Lessons Learned
Catenary Work Items

NEW HAVEN MAIN LINE

CATENARY REPLACEMENT BETWEEN STRUCTURES 236 AND 356A
CATENARY SYSTEM INTERIM CONTACT WIRE LOWERING

Metro-North Railroad Bridges in Greenwich, CT
CDOT Project Nos. 56-248, 301-0042/0044

SKETCH #1 (TO UNDERSTAND LINEAR FOOT BUST)

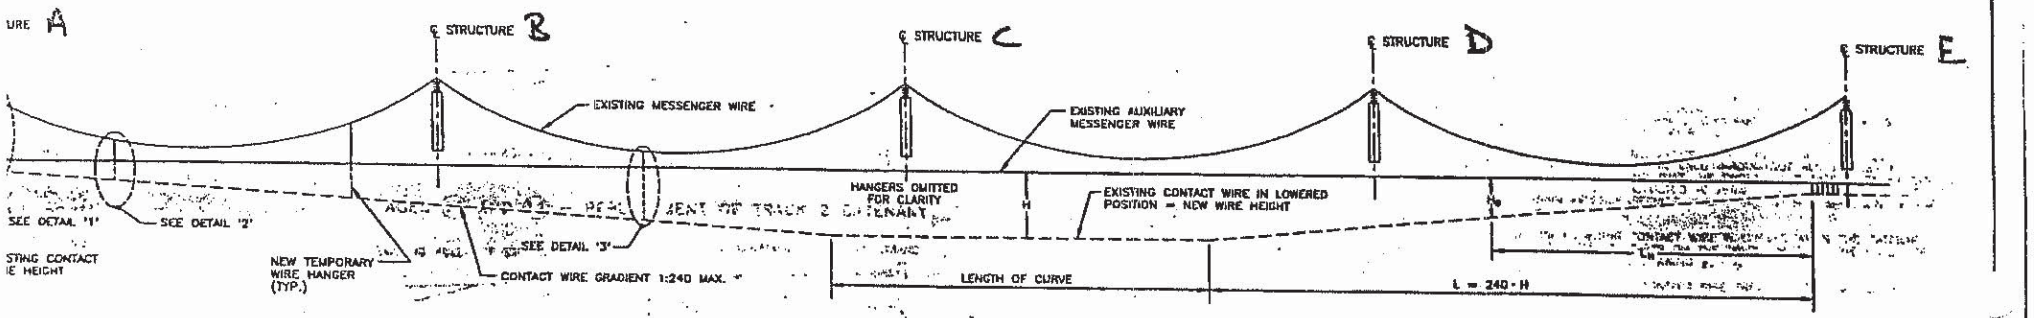
NOTE: HAD THE FIELD CONDITION LOOKED LIKE BELOW, WE WOULD HAVE PAID FROM STRUCTURE B TO STRUCTURE D. (ACCORDING TO PAY ITEM LANGUAGE)

BUT, IN REALITY WE WENT PAST STRUCTURES A & E

THEREFORE WE HAD TO PAY FROM A TO E

IN ACCORDANCE WITH PAY ITEM LANGUAGE.

SKETCH #2 TO UNDERSTAND TEMP. HANGERS

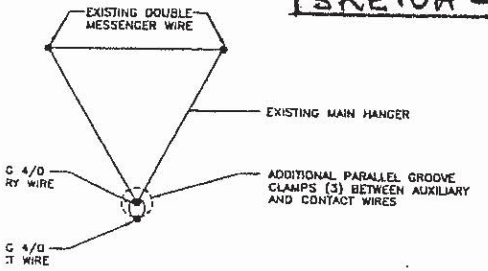
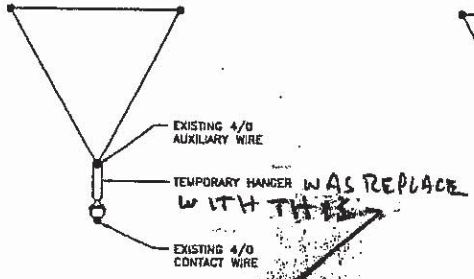
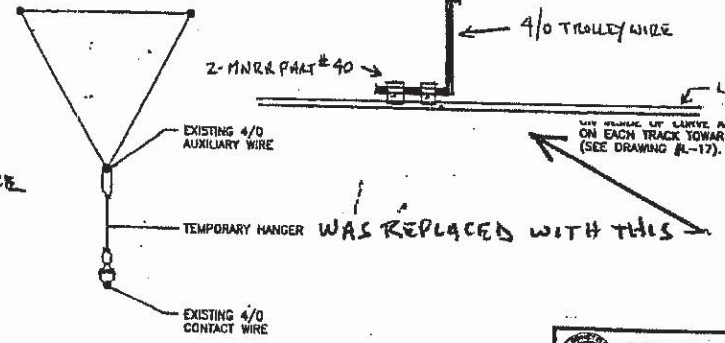
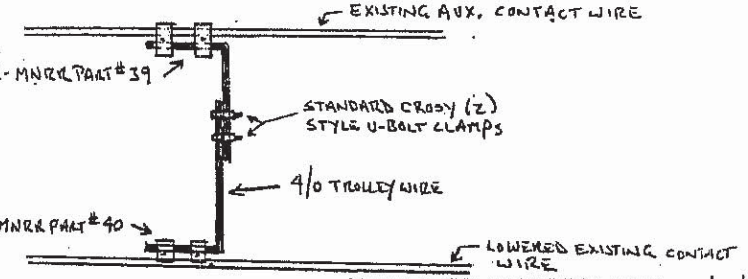
2.) TEMPORARY CONDITIONS: Lowering of Existing Catenary – MNRR did not approve the type of temporary hangers that were shown on Drawing L-15 when submitted by the Contractor. Their argument was that since the existing contact wire was fastened in a rigid manner to the messenger wire(s), MNRR desired that the temporary condition be capable of providing that same level of rigidity. As a result, MNRR accepted a proposal by the Contractor to fabricate hangers from two pieces of trolley (contact) wire. Standard MNRR parts were used to attach them to the existing catenary and common Crosby style u-bolts were used to join the two pieces together. This enabled the hanger length to be adjusted in the field (see attachment "A", sketch #2). This method worked well and pleased the Railroad. However, had the Engineer previously been made aware of the Railroad's dissatisfaction with the hangers shown on Drawing L-15, the Change Order Item #O6A0002 would have been avoided.

WAS REPLACE WITH THIS

WAS REPLACED WITH THIS

SKETCH #1

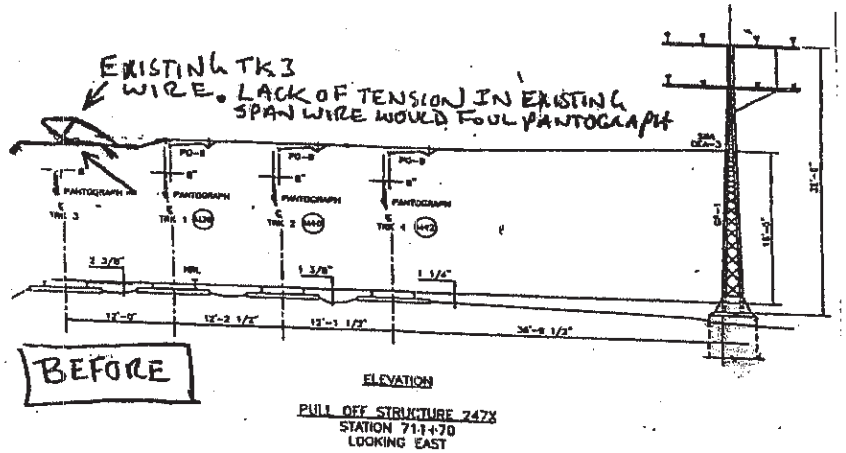
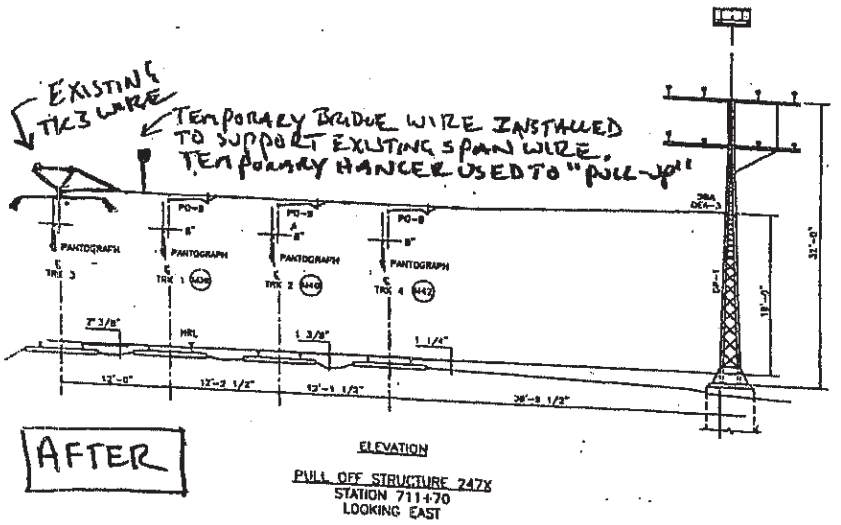
12.) INSTALLATION OF NEW CATENARY WIRE: Long-term Outages – There were initially some misconceptions on the part of a number of individuals regarding signal blocks and how these blocks relate to outages and catenary wire runs. Looking at contract drawing L-19, we can see how the railroad perceived that the outage phases should be conducted. A full understanding of these relationships was gained by the Project over time, and the following information may be beneficial for use in the planning of future work. The Project's interlock (Green) is shown on the referenced drawing. In simple terms, the sketches on the drawing could lead one to assume there is a west block and an east block, which there are. However, the interlock itself is its own

third block, and the outages required to complete work in that third block are not specifically shown on this drawing. In addition, the two inside tracks are configured electrically different than the two outside tracks. The electrical separation is accomplished through catenary insulated overlaps. The nature of these catenaries is such

that they must extend into the adjacent electrical section in order to terminate. To complicate matters, the outside tracks do not have the same electrical separation points as their signal separation points, so limits of outages will be impacted. This starts to get very detailed, attachment "B", sketch #1 is offered to try and illustrate this point. In summary, future projects might well consider additional diagrams and outage phases in a manner which reflects these complex field conditions. Many complications for the Project arose out of additional outage requests that were not fully understood by MNRR's downtown management, due to the fact they were not specifically diagramed and understood in the planning phase.

The contract drawings L-18 to L-20 accurately depict the electrical switching limits. They do not clearly indicate the signal (track) limits or the new catenary limits. All of the new catenaries extend beyond the electrical and signal limits as they go out-of-running and terminate.

There are three elements to consider when planning the required outages:

1.) The signal (track) limits.
2.) The electrical limits.
3.) The catenary wire run limits.

ATTACHMENT "C"

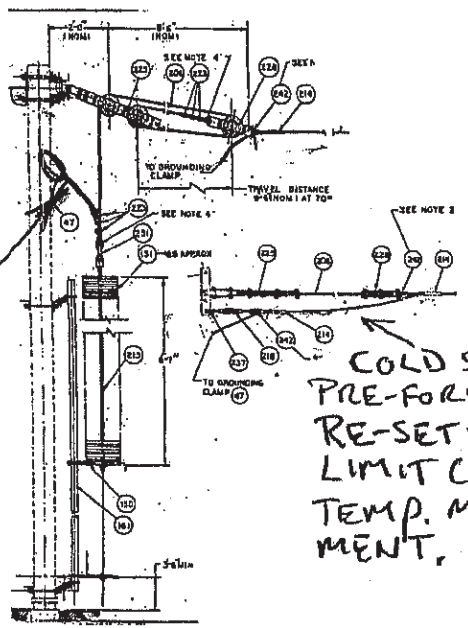
5.) TEMPORARY CONDITIONS: Temporary Cross-overs – One of the most difficult aspects of the Project was making the new Auto-Tension (A.T.) catenary function properly next to the existing Fixed-Tension (F.T.) catenary. This is most difficult at the interlock cross-over tracks, where a F.T. cross-over wire turns out from a A.T. mainline track. The A.T. wire height remains constant, but the F.T. wire height rises and falls with temperature. Tolerances are tight in these "turn-out" areas. In response to this matter, the Project devised a system to prevent the inherent problems of combining the two wire types. By modifying a MNRR deep knuckle assembly with extra hangers going from one wire run to the other, combined with movement restrictions placed at the A.T. wire balance weight, the problem was solved (see attachment "C"). Utilizing this method offered the advantages of A.T. catenary while minimizing the risks associated with sagging and hogging (rising) of the existing F.T. system. It is recommended that this procedure be passed on for use in future projects.

ANOTHER S.S. ROPE WAS USED TO RESIST RISING OF THE FIXED-TENSION MESSENGER

TEMP. 3/8" STAINLESS WIRE ROPE TO AID IN PREVENTING SAGGING OF X-OVER WIRE

NOTE: IF USED FOR MORE THAN ONE SEASON SPRING AND FALL ADJUSTMENTS REQUIRED.

NOTE: CROSS-OVER WIRE ALSO SUPPORTED FROM CLOSEST STRUCTURE, EVEN IF NEW DESIGN DOES NOT CALL FOR THAT (LIMIT SPAN LENGTH)

SLACK EXTENDED AND FASTENED TO POLE BY LOOPING AROUND LACING TO LIMIT HOT TEMP. MOVEMENT

COLD STOP PRE-FORM RE-SET TO LIMIT COLD TEMP. MOVEMENT.

ATTACHMENT "D"

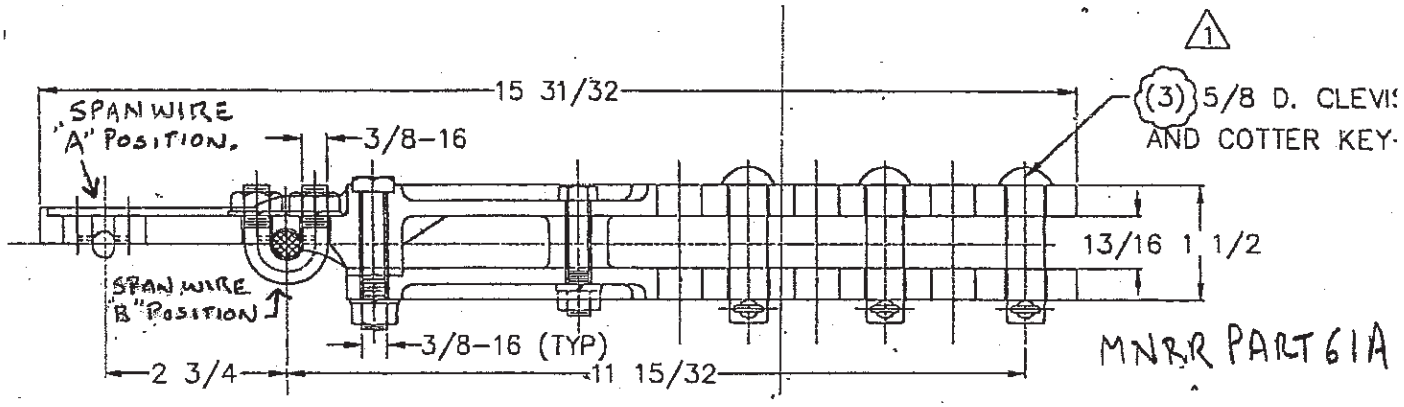
24.) INSTALLATION OF NEW CATENARY WIRE: Pull-off's – It is recommended that double span wire pull-off's not be used unless absolutely necessary. Working with these pull-off's in the field, it was discovered that a single span pull-off can accommodate a larger system depth than shown on the drawings, in-turn enabling the Project to eliminate several double wire types. The basic design does not consider the heel setting or the slight sag which normally occurs due to the weight of the assembly. This essentially enables the single wire type to handle system depths of approximately 22". It is recommended that the single wire type be allocated for system depths up to that value. We found that a 24" system depth required a double wire assembly, but a 23" depth could be effectively pulled by the single wire span. See attachment "D" to better understand this and the issue of Field Directive #112. The allocation of these assemblies is directly related to the Engineer generated hanger tabulations. The actual system depth to be encountered is somewhat estimated by the Engineer during the design phase. This estimate is used to determine the type of assembly to be allocated and the height of the span bracket(s) supporting the pull-off wires. Once the Contractor is sure of his field conditions, he then orders the hanger tabulations from the Engineer. It is not until the hanger tabulations come back from the Engineer that the Contractor is sure of the system depth that will actually be installed in the field. In short, the elimination of rework (see attachment "E", sketch #2) on the bracket installation (to achieve the correct height) and all of the extra work (twice as much) involved with the double wire pull-off may be avoided if the estimated hanger tabulations were analyzed more closely ahead of time.

PO-1's & PO-2's as shown on Drawing E-4 can generally accommodate system depths between 18 and 23 inches. This is primarily due to the fact that the PO-6, 9 & 10 shown on Drawing E-7 can accommodate an additional 3 inches of system depth than indicated on the drawing. This just naturally increases the system depth the PO-1 & 2 can handle.

Below are examples of why the pull-off's can be used for larger system depths than the MNRR standards show. Luckily for the Project, many pull-off installation allocations were not in line with the standard, enabling the Project to not have to justify them being installed in a manner that did not conform with the E-4 & 7 drawings.

Note: When span wire is in the "A" position, dimensions add-up to the following when heel distance is included: (2.75" + 11.5" + 2.5" = 16.75").
With the introduction of gravity on the mass of the bracket, the sag in the field (approx. 1.25") enables this PO bracket to accommodate a system depth of 18".

These are examples of Pull-off's whose installation allocations did not conform with the E-4 and E-7 drawings, but were fine in the field. [EXCEPT 246X, TK4).

The following could guide the possible revision of drawings E-4 & 7
PO-6: (9" to 12")
PO-9: (12" to 18")
PO-10: (9" to 18")
PO-1 & PO-2: (18" to 23")
PO-3, 4 & 12: (24" and greater)

ATTACHMENT "E"
SKETCH #1

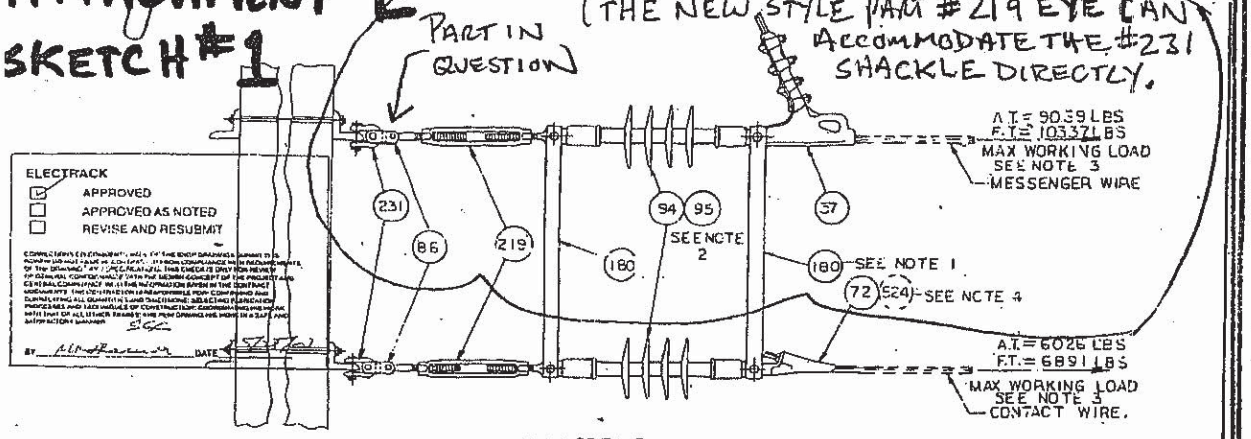
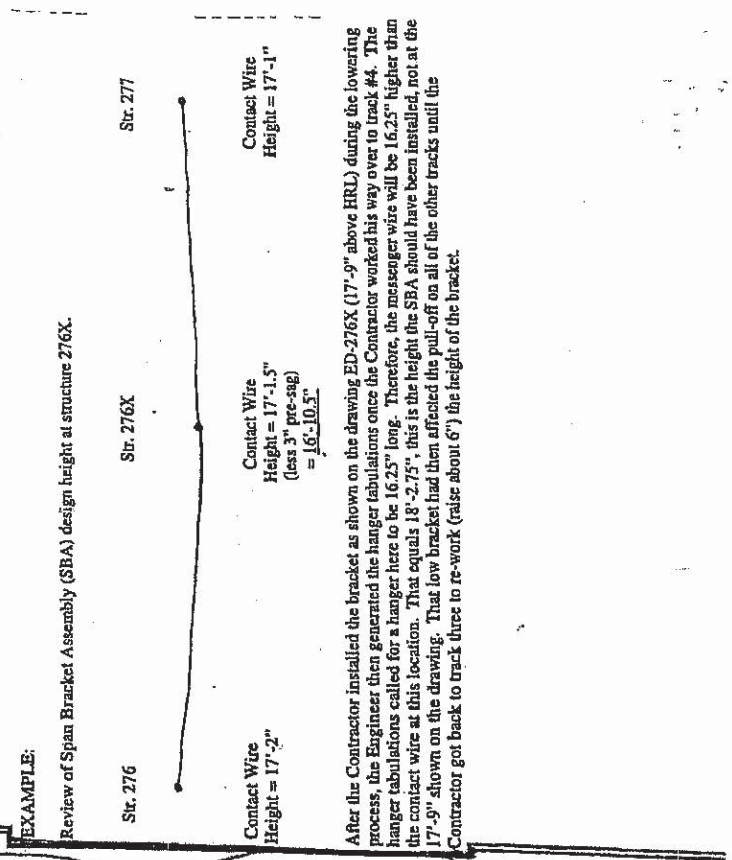
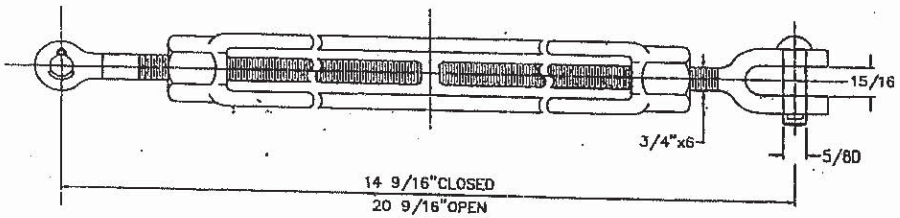
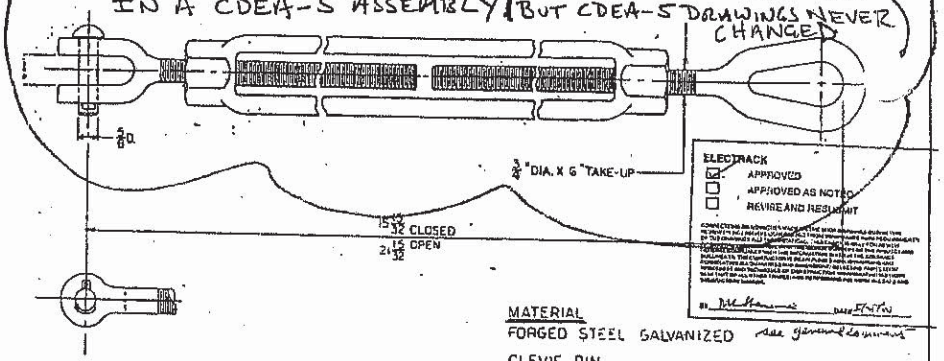
27.) INSTALLATION OF NEW CATENARY WIRE: Assembly Shop Drawing – The CDEA-5 assemblies had an improperly documented change that appeared to be generated by the manufacturer. This caused enough confusion with the MNRR catenary inspectors to note it here. The Project recommends that this drawing conflict be corrected. A different style turnbuckle was introduced by the Dossert Co., and that style appeared to eliminate the need for another component (Part #86) that was allocated to be in the assembly. However, the changed assembly shop drawing was never re-issued to the Project. Attachment "E", sketch #1 is given to better illustrate the recommendation.

(THE NEW STYLE PART #219 EYE CAN ACCOMMODATE THE #231 SHACKLE DIRECTLY.

THIS WAS THE ORIGINAL PART #219, IN WHICH A PART #86 WAS REQ'D WHEN USED IN A CDEA-5

WHEN DOSSERT INTRODUCED THIS STYLE PART #219 DUCCI BEGAN TO ELIMINATE ~~THE~~ PART #86 IN A CDEA-5 ASSEMBLY (BUT CDEA-5 DRAWINGS NEVER CHANGED)
